Project	IEEE 802.16 Broadband Wireless Access Working Group < <u>http://ieee802.org/16</u> >					
Title	Problem with Data Mapping for OFDMA PHY in DL PUSC Zone					
Date Submitted	2005-07-09					
Source(s)	QunFang Lou, Hebing Wu, Michael (Jibin) Wang, Tao Li, John Lee, Lili Huawei/FutureWei (Huawei North America Division) 3255-4 Scott Blvd.Suite 101, Santa Clara, CA 95054Voice: +86-21-68644808 408-712-9326 					
	Huawei Technologies Co., Ltd. No.98, Lane 91, Eshan Road, Pudong Shanghai, P.R. China, 200127					
Re:	IEEE P80216Cor1/D3					
Abstract	Problem and solution with data mapping approach for OFDMA PHY in DL PUSC zone					
Purpose	For adoption					
Notice	This document has been prepared to assist IEEE 802.16. It is offered as a basis for discussion and is not binding on the contributing individual(s) or organization(s). The material in this document is subject to change in form and content after further study. The contributor(s) reserve(s) the right to add, amend or withdraw material contained herein.

Problem with Data Mapping for OFDMA PHY in DL PUSC Zone QunFang Lou, Hebing Wu, Michael (Jibin) Wang Tao Li, John Lee (Jiang Li), Li Li, Huawei Technologies Co., Ltd.

Fig. 2 Simulation results of proposed solution and the existing sulution Table 2 lists the of Eb/No(dB) requirements of the proposed solution and the existing solution at

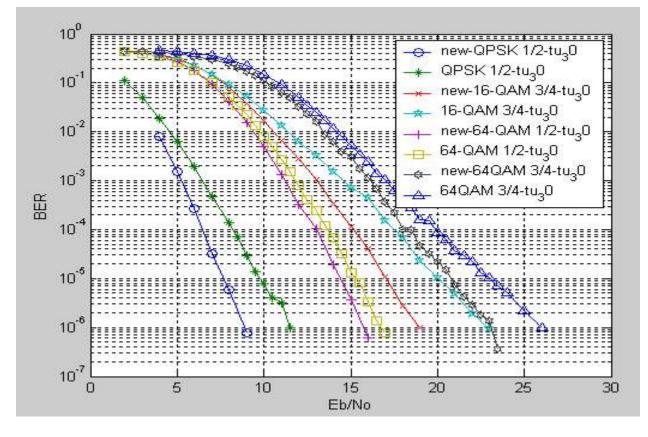
Here, a new data mapping scheme is proposed to achieve better performance. Simulation results show that 1~3.5dB gain can be obtained at BER=1e-6.

Simulation results under the simulation condition listed above is shown in Fig2.

For downlink PUSC using the distributed subcarrier permutation (defined in 8.4.6.1.2.1), one slot-is one subchannel by three OFDMA symbols. consists of two different subchannels in two successive OFDMA symbols. Assume L subchannels are allocated to the user with indexes k, k+1,...,k+L-1, and the subchannel index for the first OFDM symbol in the slot is m, then the subchannel index for the second symbol in the slot is k+mod(m-k+L/2,L).
For uplink PUSC using either of the distributed subcarrier permutations (defined in 8.4.6.2.1 and 8.4.6.2.5), one slot is one subchannel by three OFDMA symbols.
